RE: JMC Project 22090  
BaySpace Armonk  
100 Business Park Drive  
Town of North Castle, NY

**Response to Town Comments Resubmission**

Town of North Castle Planning Department Memorandum, dated June 19, 2023

Drawn: NC Approved: DL  
 Scale: NOT TO SCALE  
 Date: 09/12/2022  
 Project No: 22090  
 2209-SE COVER COVER.dwg  
 Drawing No: C-000

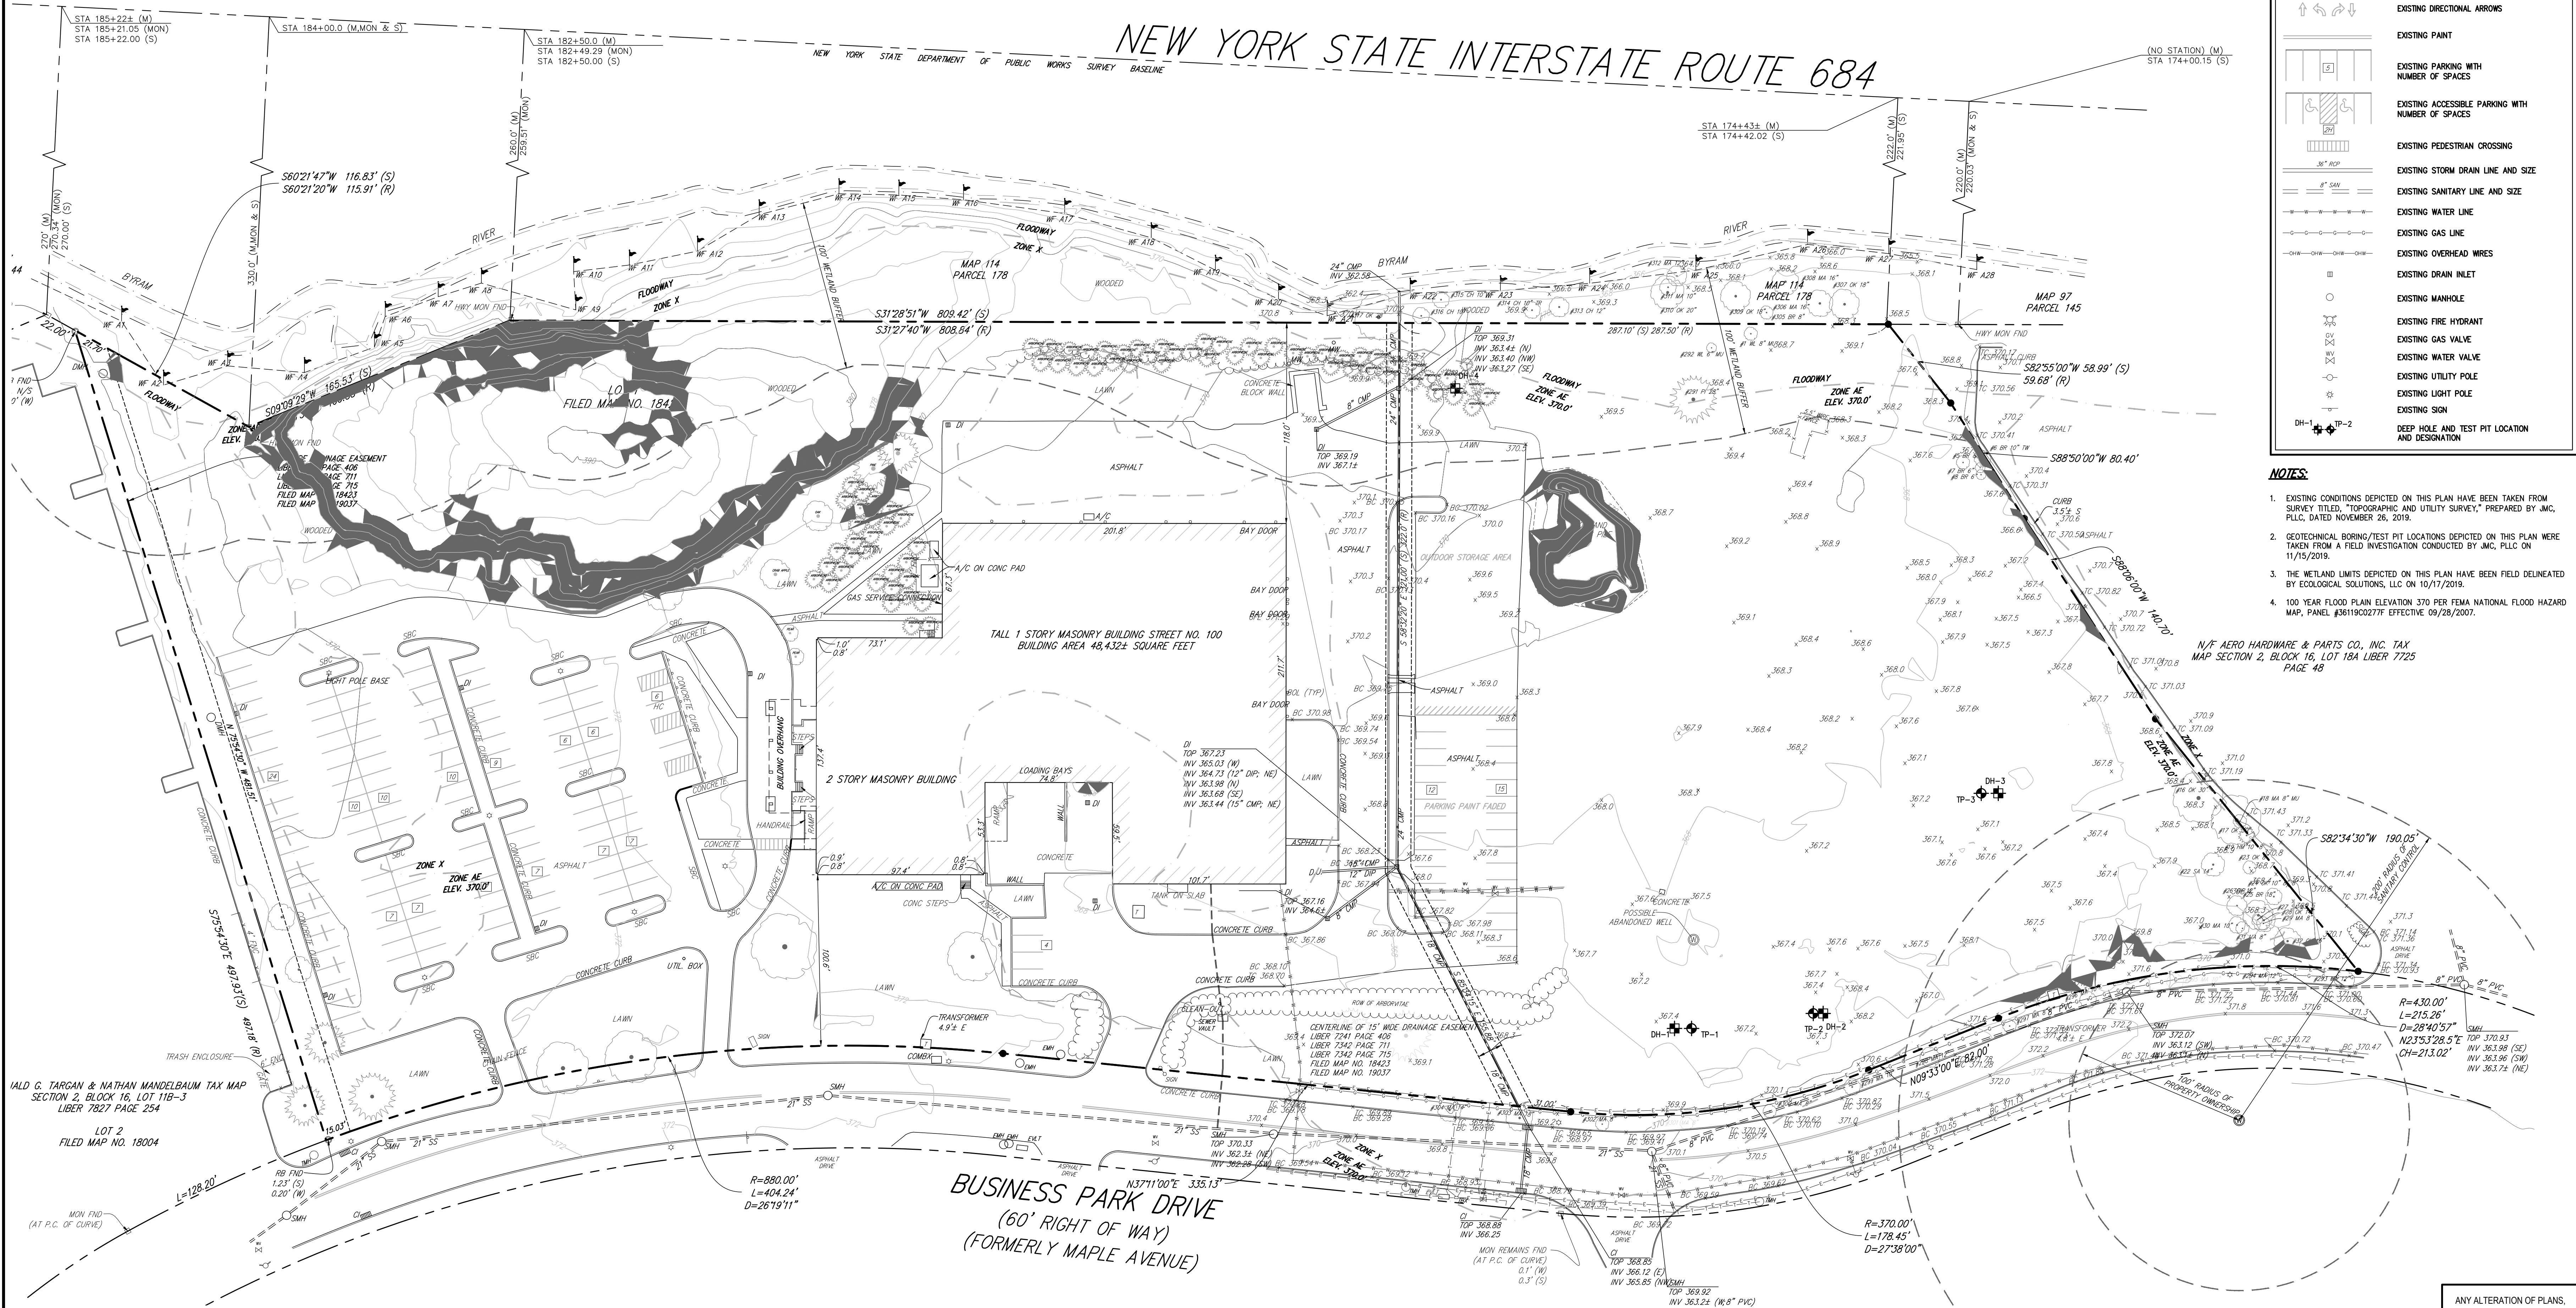
Comment No. 10

The proposed parking calculations have been revised to identify the amount of recreation facility square footage that excludes the area of the pickleball courts (6,777 SF), refer to Drawing C-000.

**A0-01**

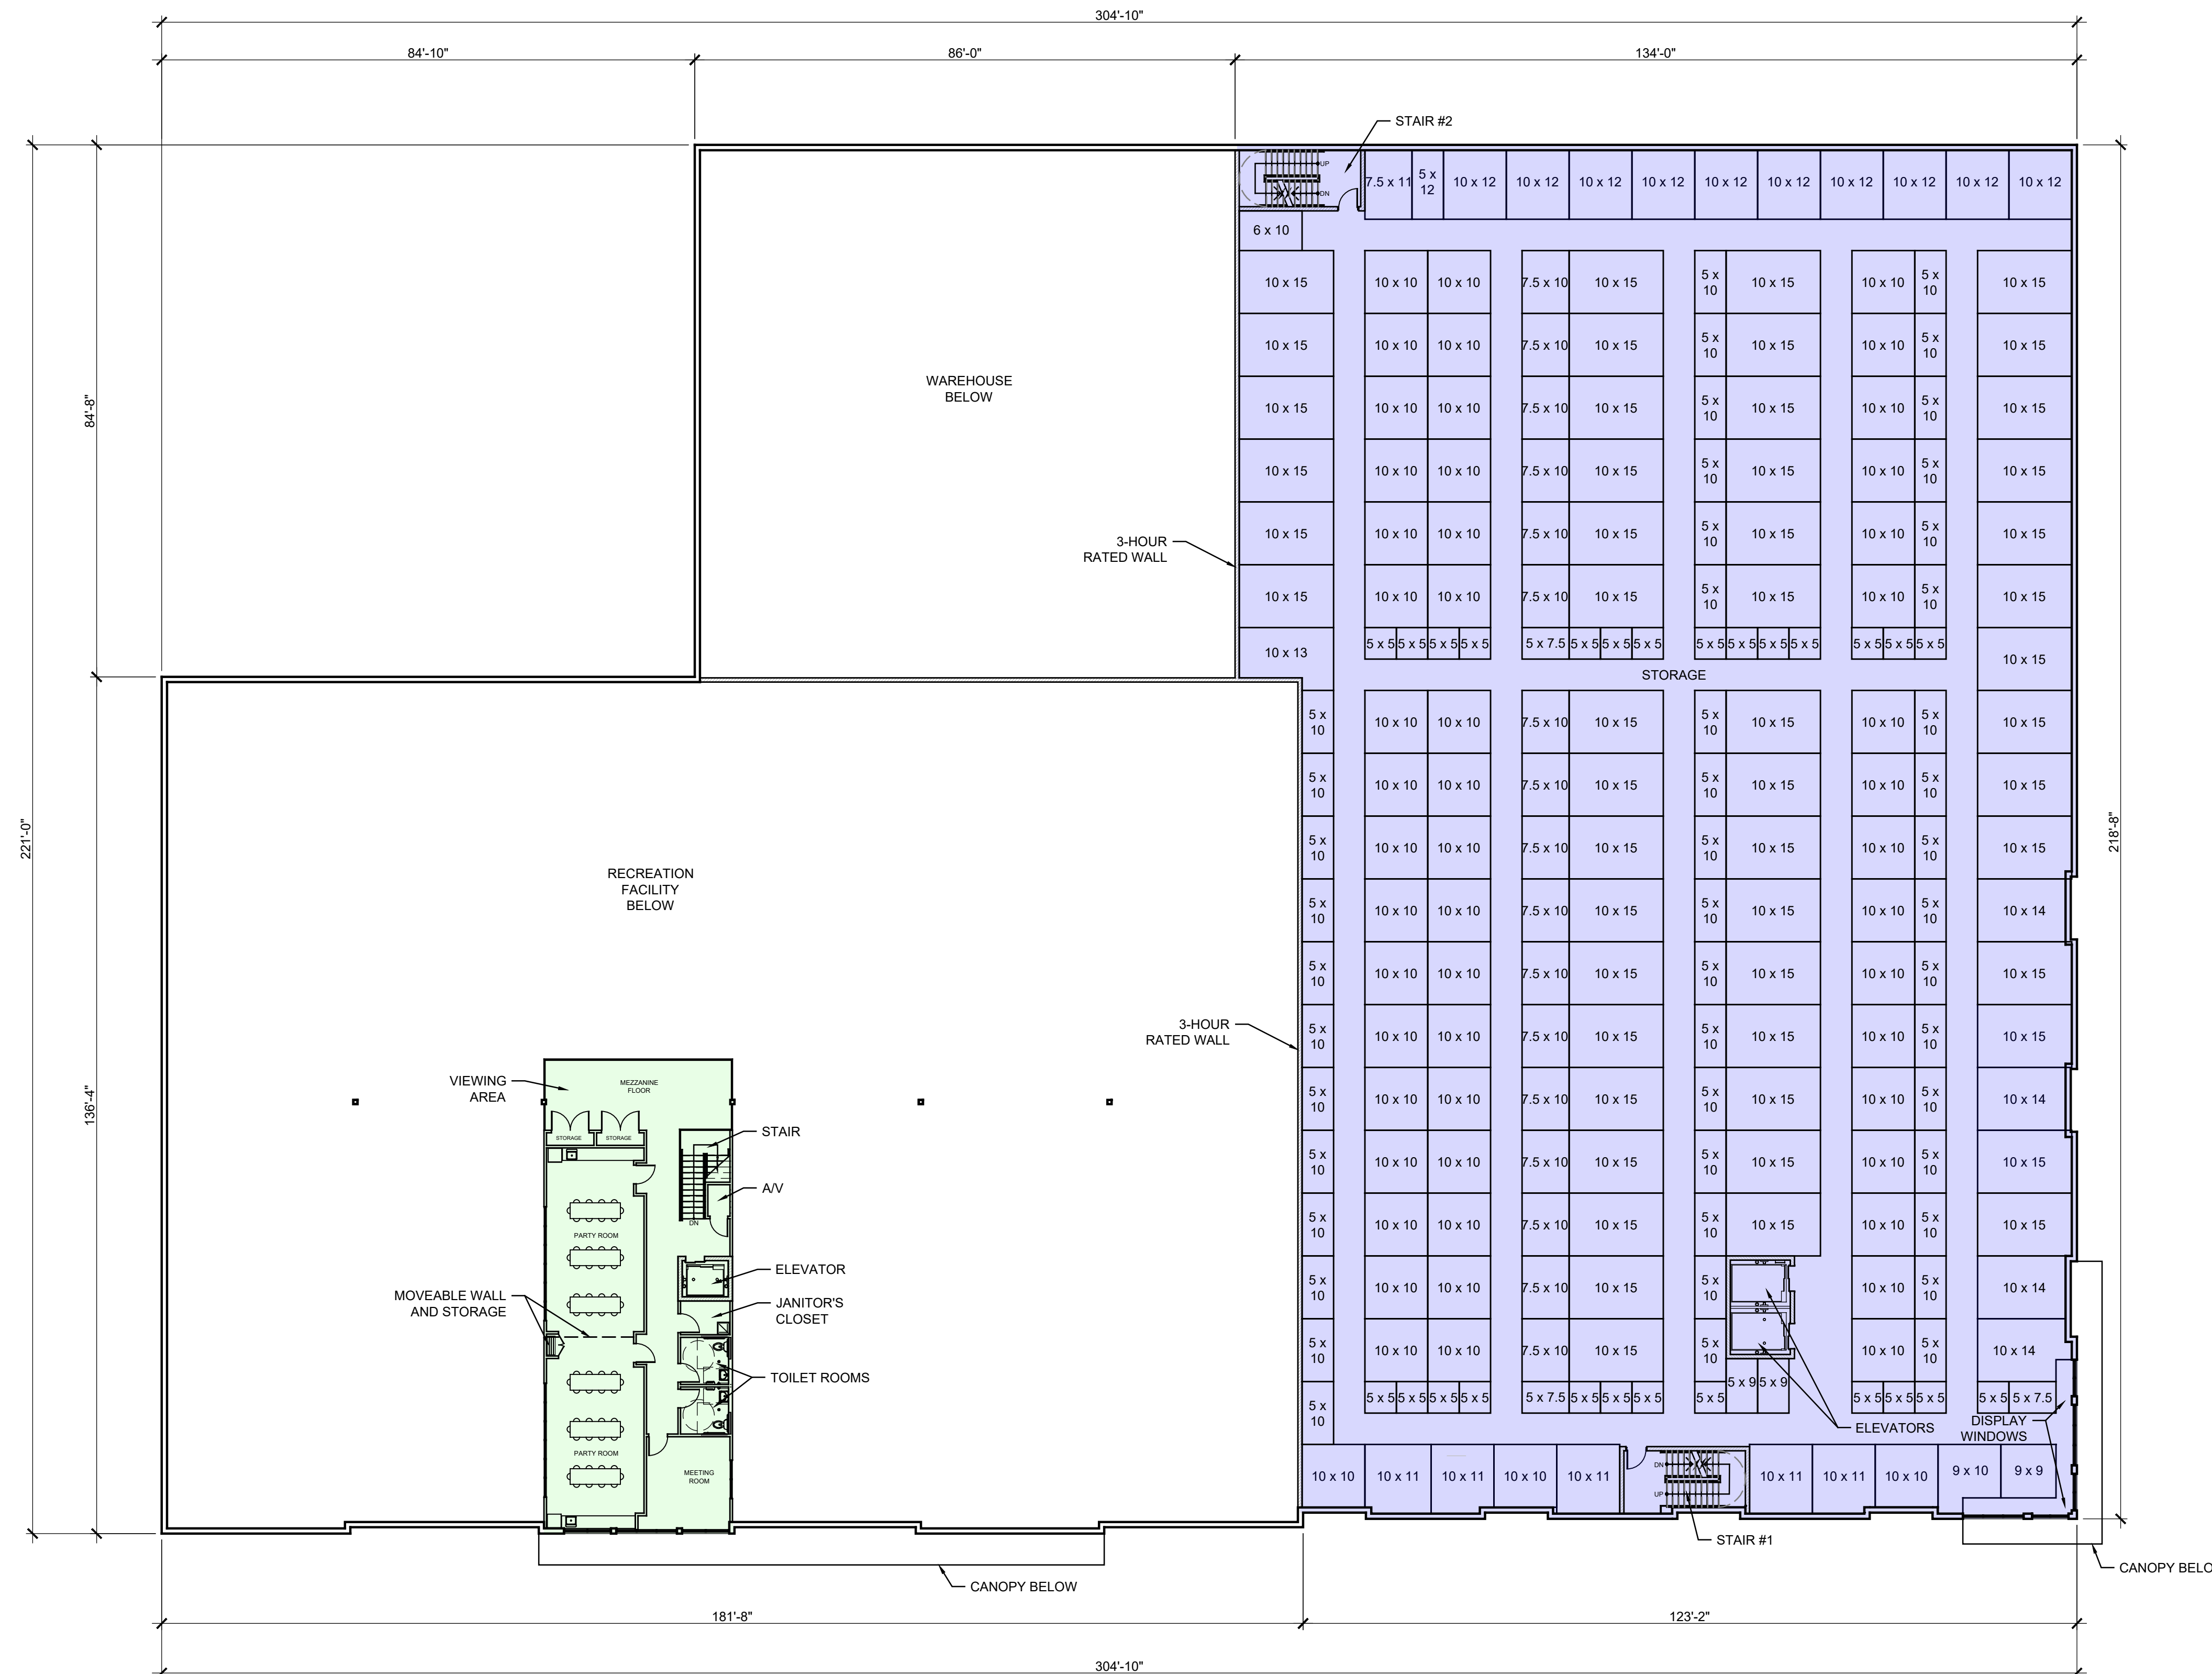
*The plans need to indicate the location of the fire department connection.*

The fire department connection location has been added to the plans, refer to Drawing A0-01 prepared by SGW Architecture & Design.

A2-01

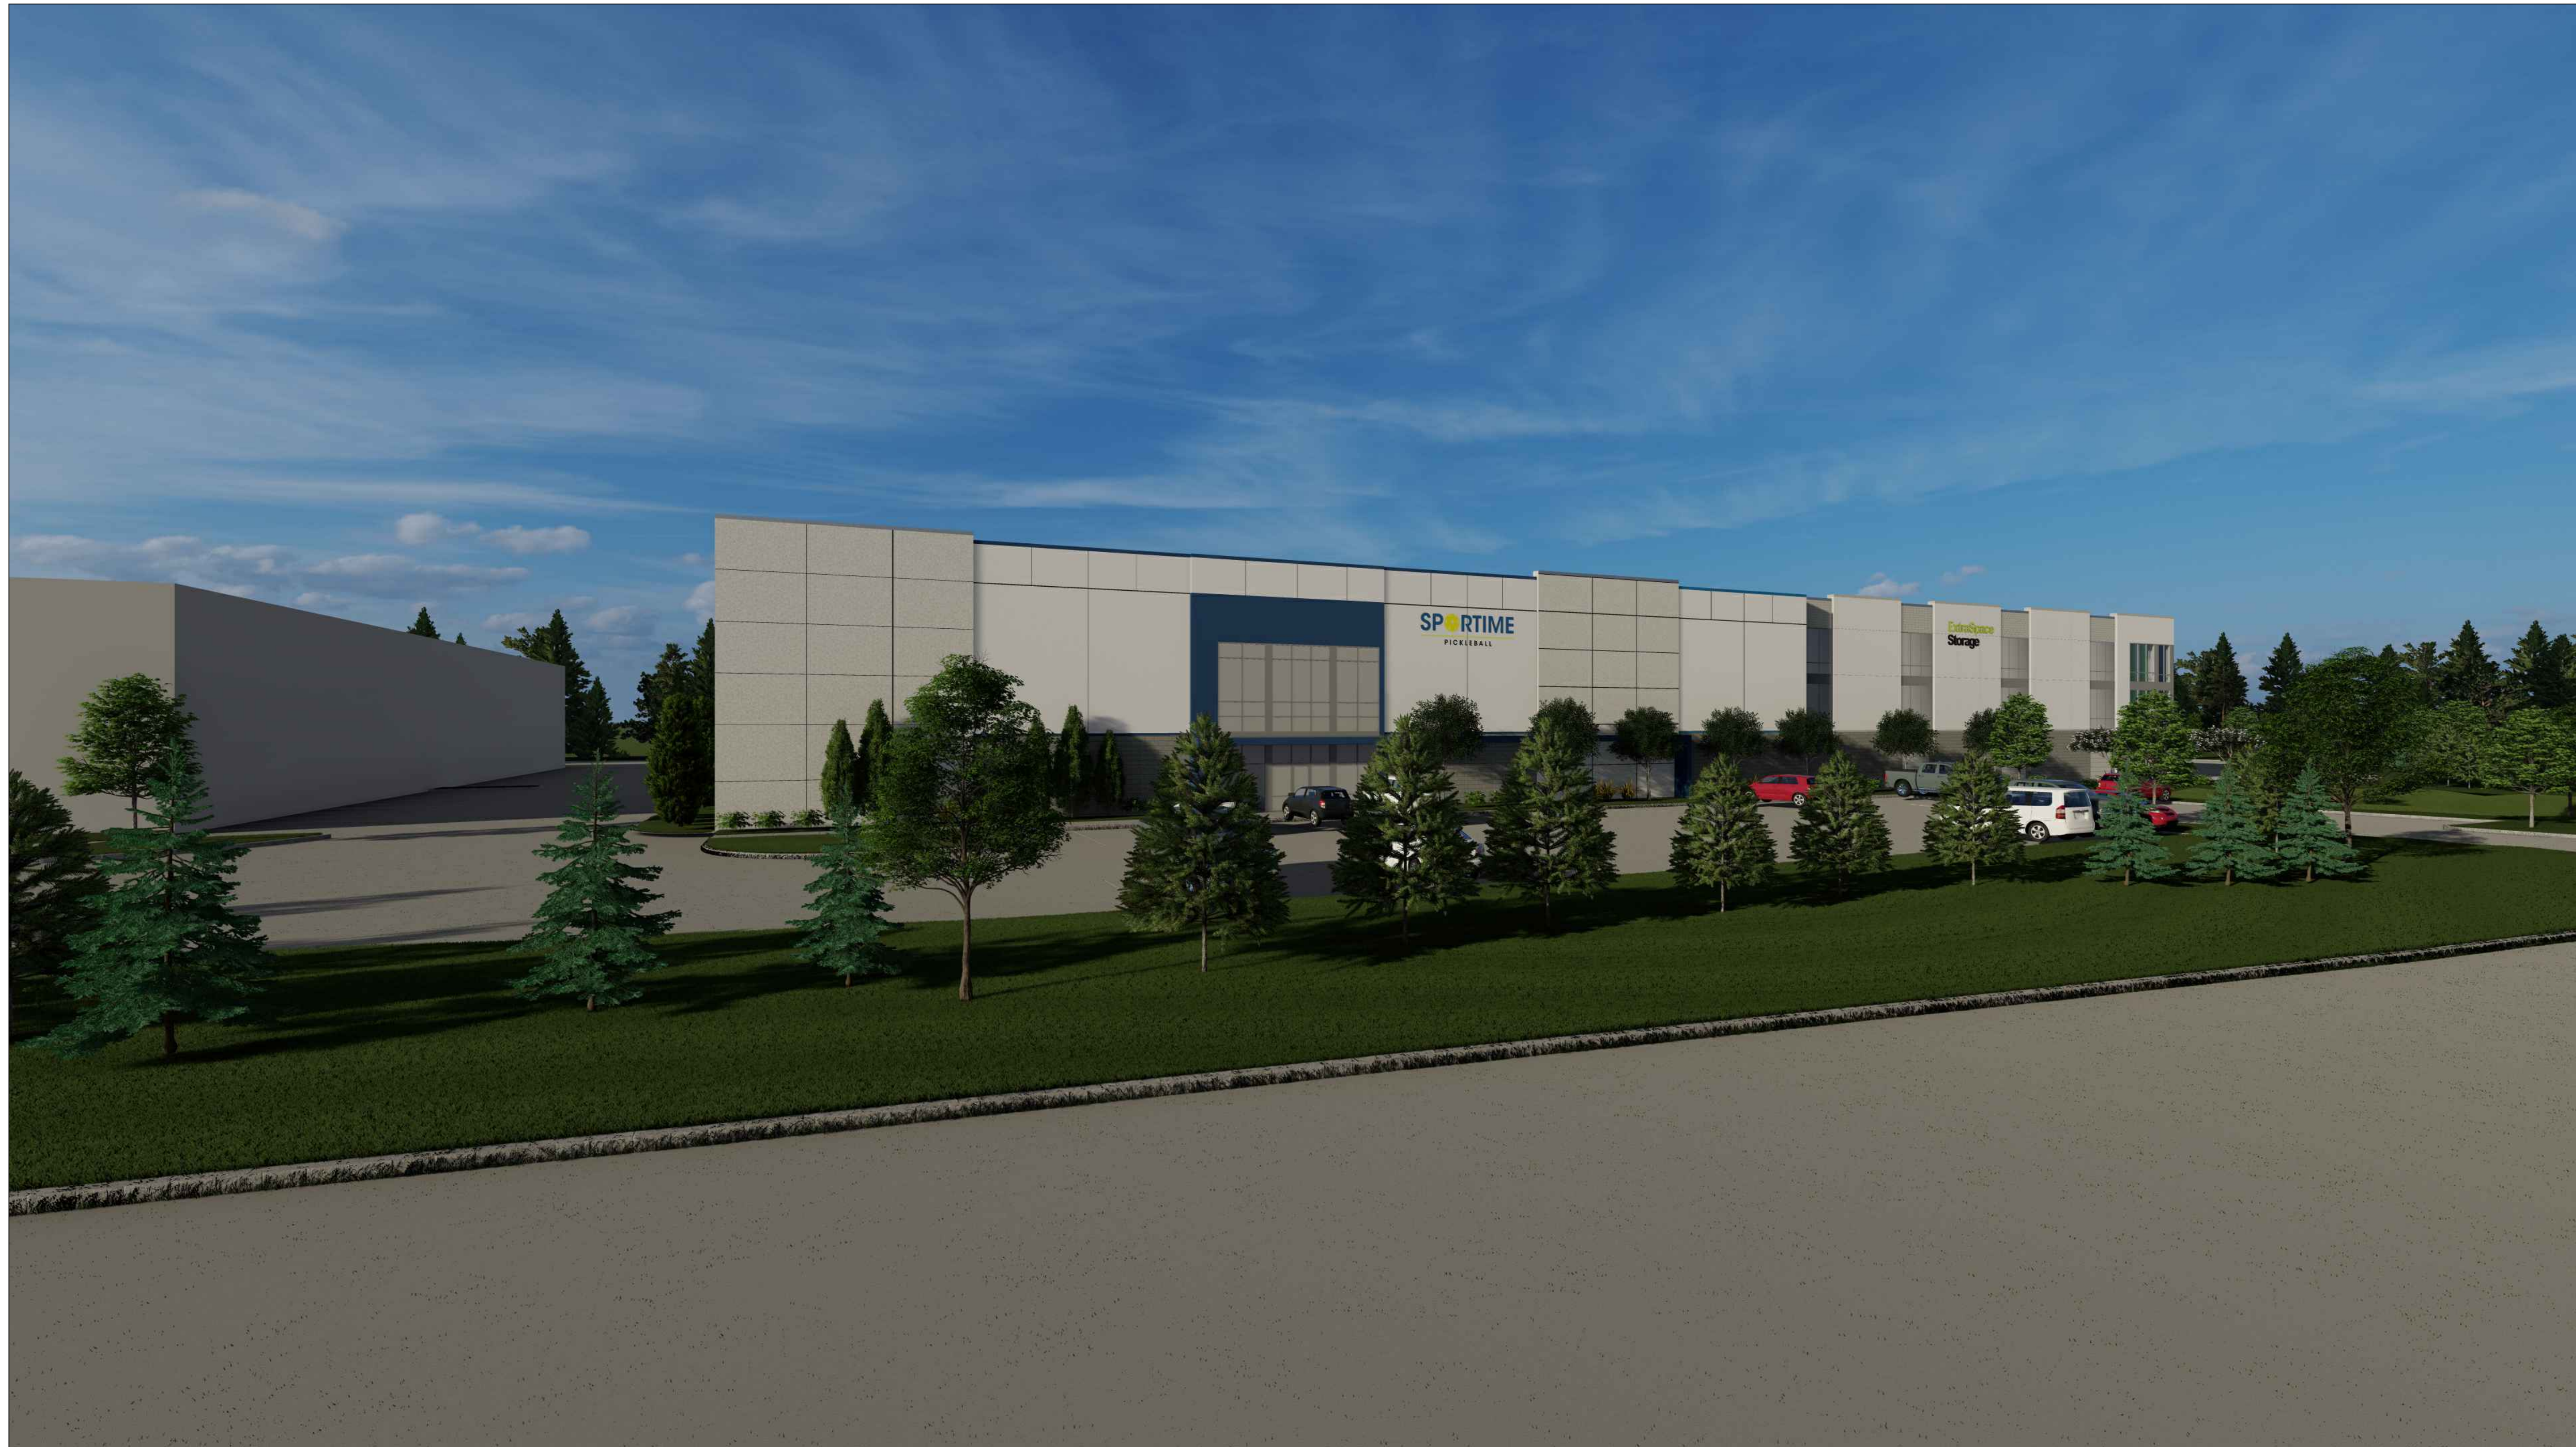
*The submitted elevations shall be revised to depict proposed Building Height (average grade to top of roof). Building Height can't exceed 35 feet in the PLI Zoning District.*

The building elevations have been revised to depict the proposed building height (average grade to top of roof). The proposed building height (34.7') is fully compliant with the PLI Zoning District height regulations.
